JOB TITLE:
PROPOSED BLUE SKILLS TRAINING FOR EMPLOYMENT CENTRE (BSTEC) FOR THE KISUMU NATIONAL POLYTECHNIC ON KISUMU MUNICIPALITY / BLOCK 9 / 101

DRAWING TITLE:
SITE PLAN

P-150	DRG. NO: 01	REVISION:	DRAWN BY: J.O.O.
	SCALE: 1:300	DATE: MAR 2026	CHECKED BY: O.M.

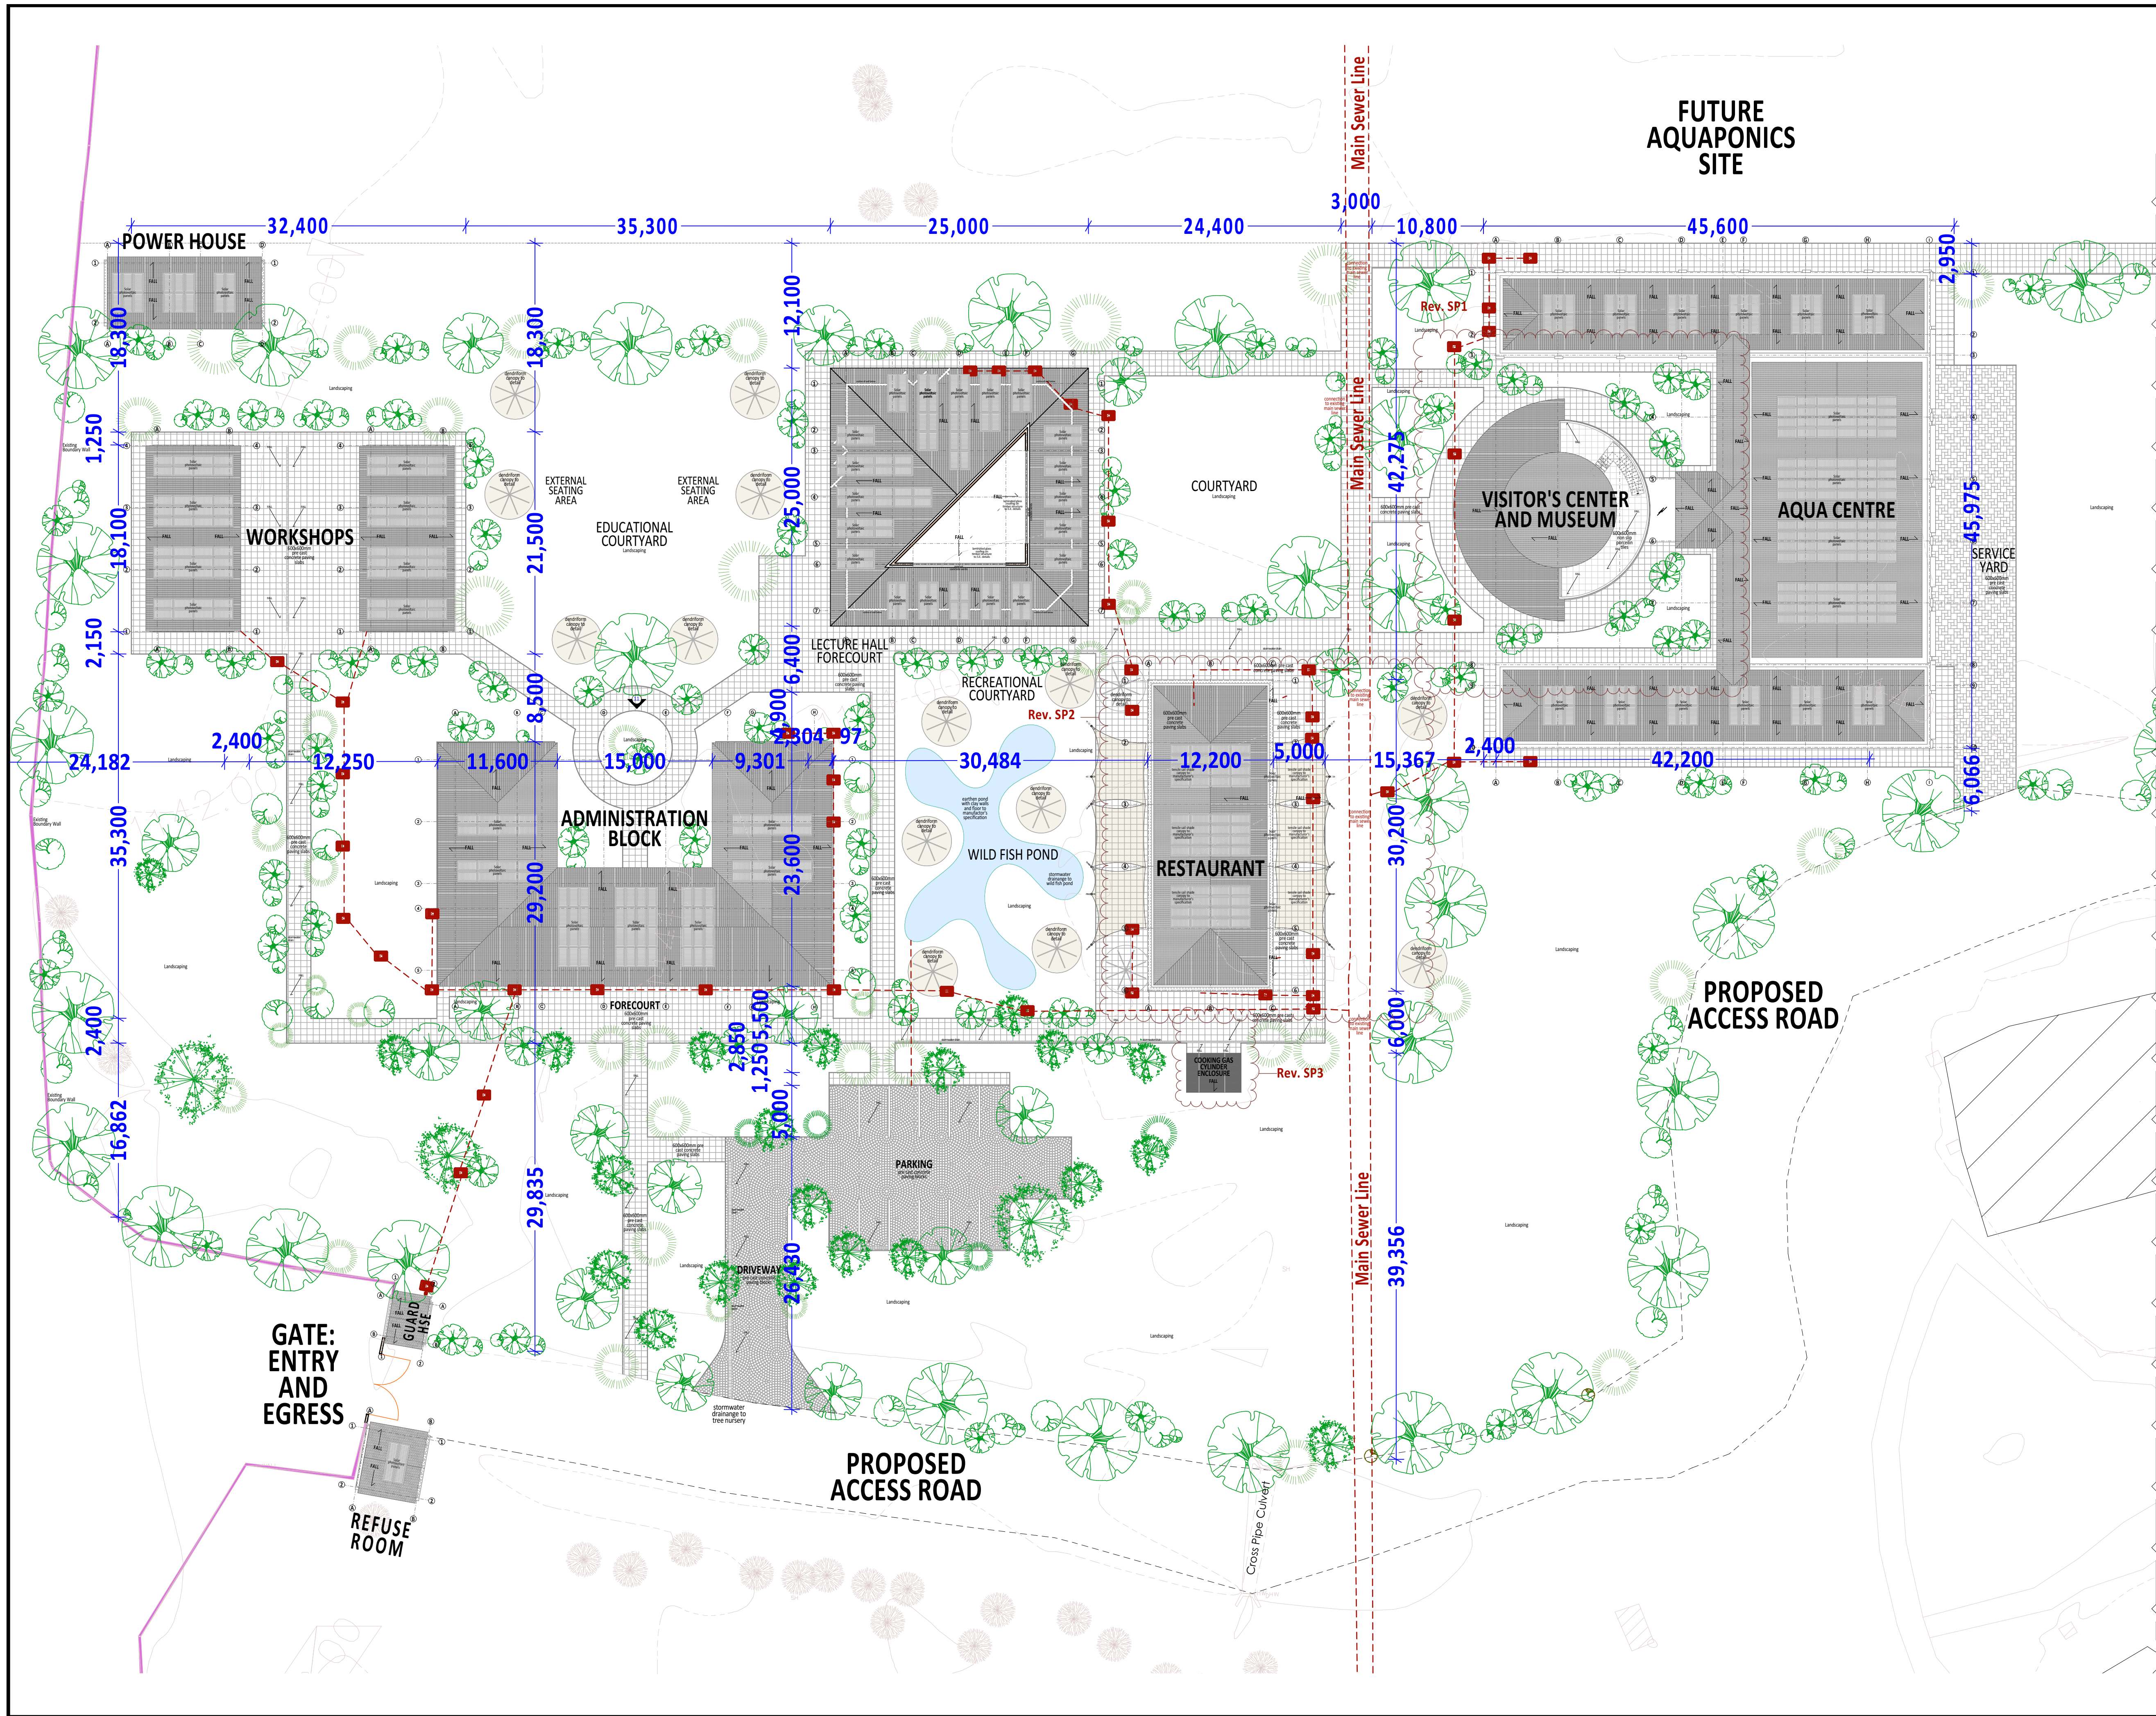
No.	Date	Revision/Issue
Rev. SP1	15/06/26	Paving reduced in Aqua Center forecourt for soft landscaping
Rev. SP2	15/06/26	Restaurant repositioned 6 meters from main sewer line
Rev. SP3	17/06/26	Cooking gas cylinder enclosure introduced 6 meters from Restaurant building

DRAWING TITLE:
WORKSHOP 1 - PLAN, ELEVATIONS 09-12, SECTION C-C', WORKSHOP 2 - ROOF PLAN, PLAN ELEVATIONS 13-16.

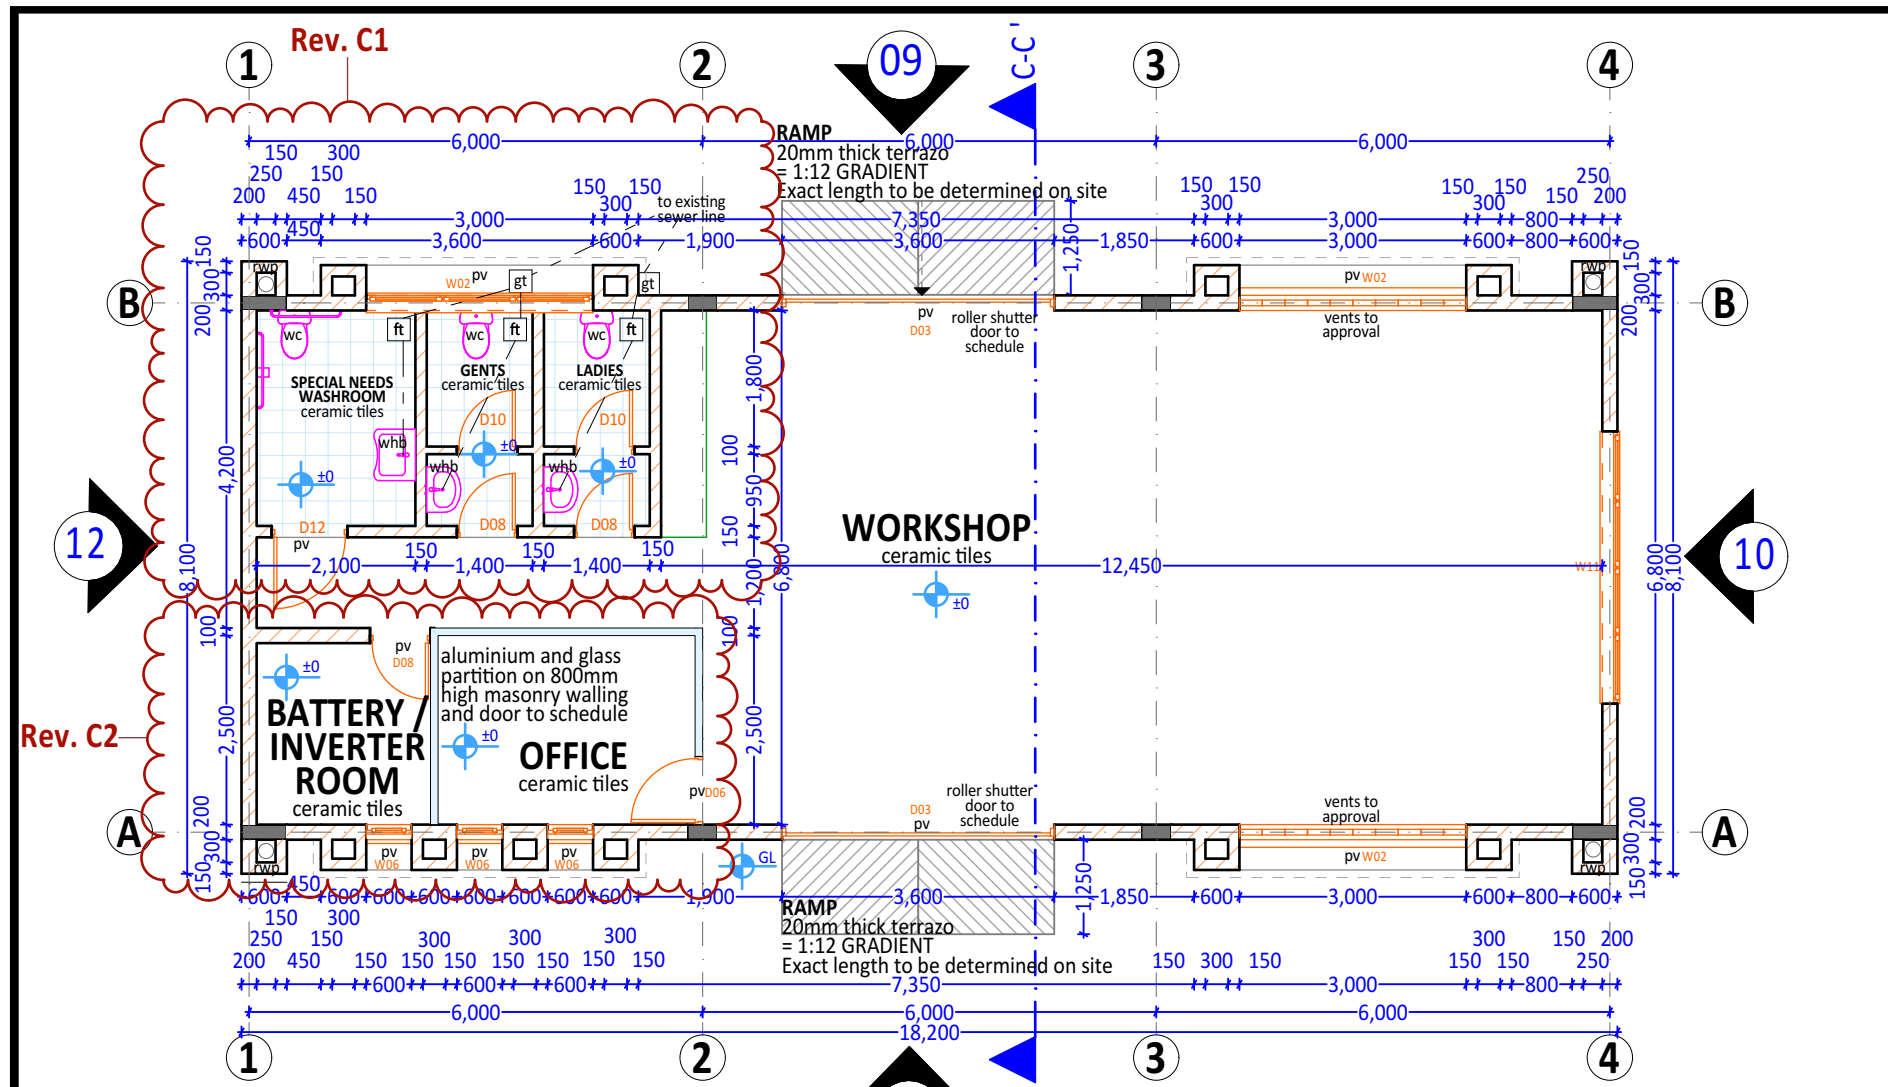
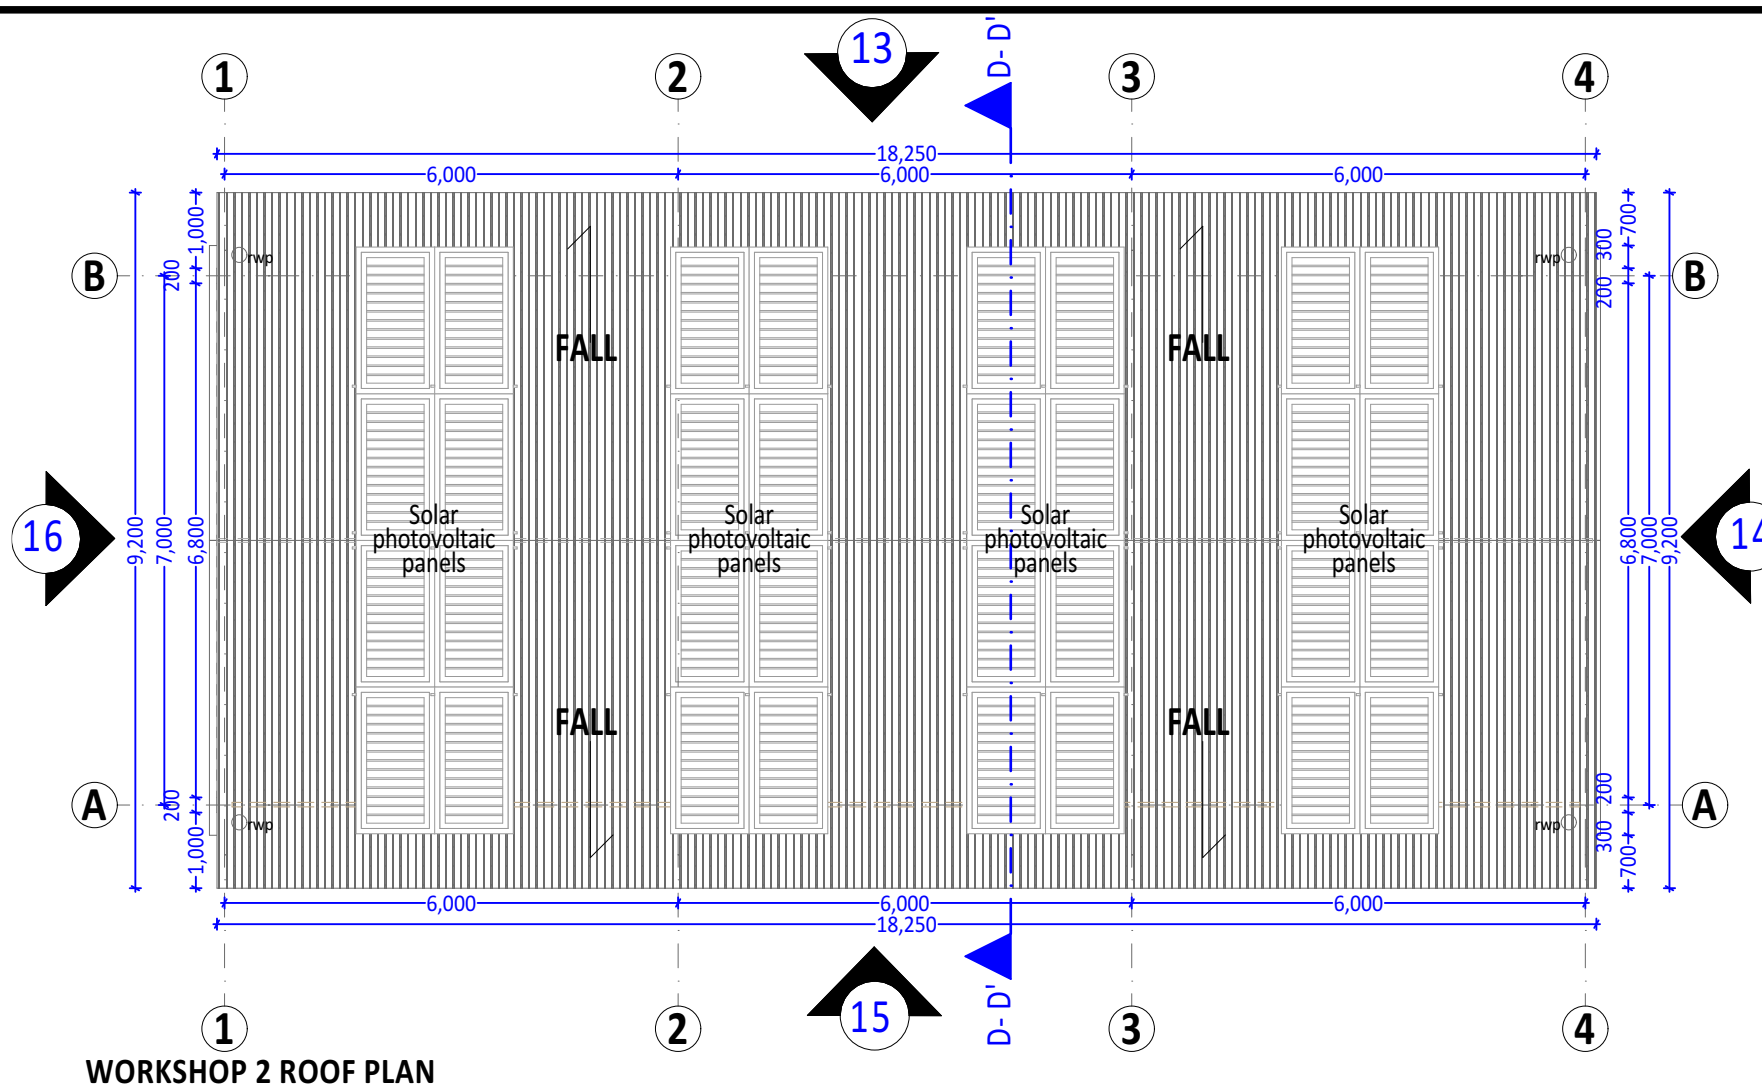
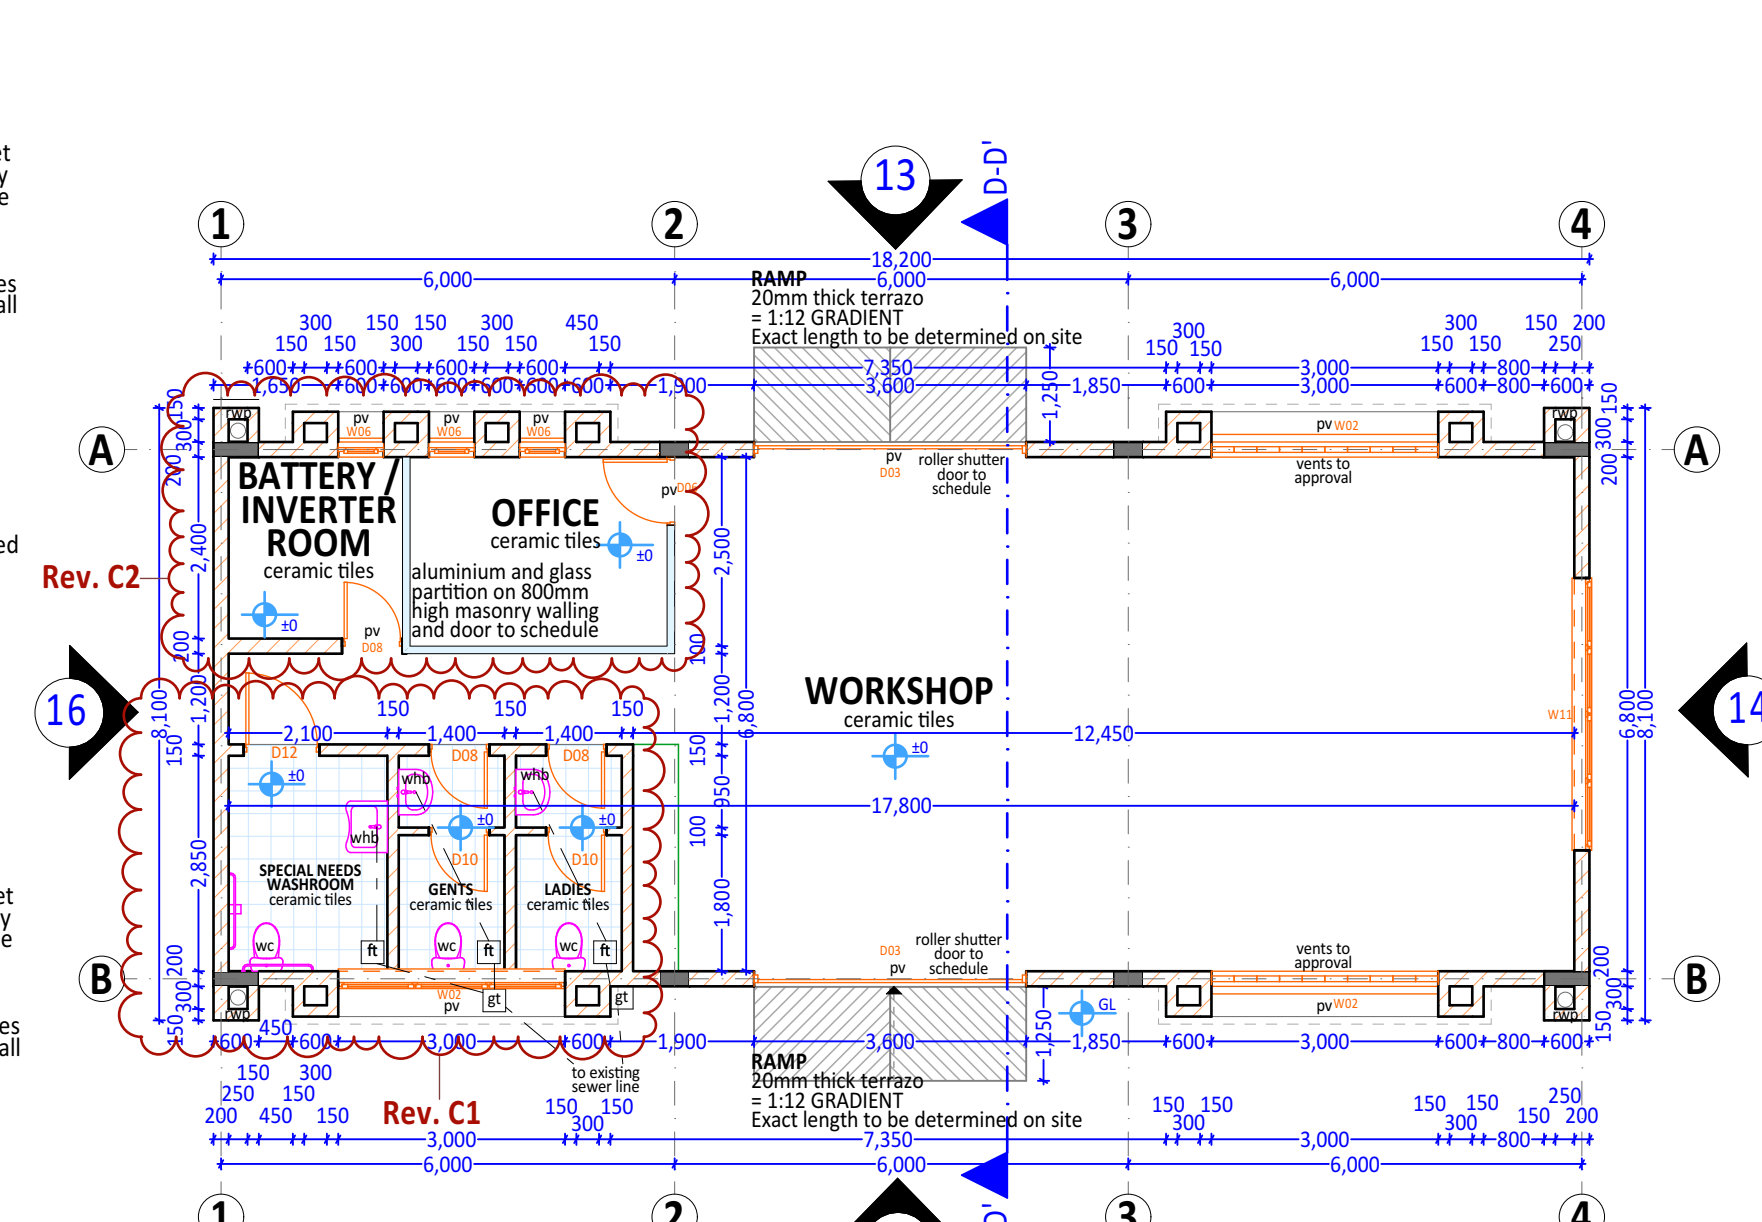
No.	Date	Revision/Issue
Rev. C1	15/06/26	Washrooms introduced into the Workshops
Rev. C2	15/06/26	Sizes of the battery / inverter room and office reduced.
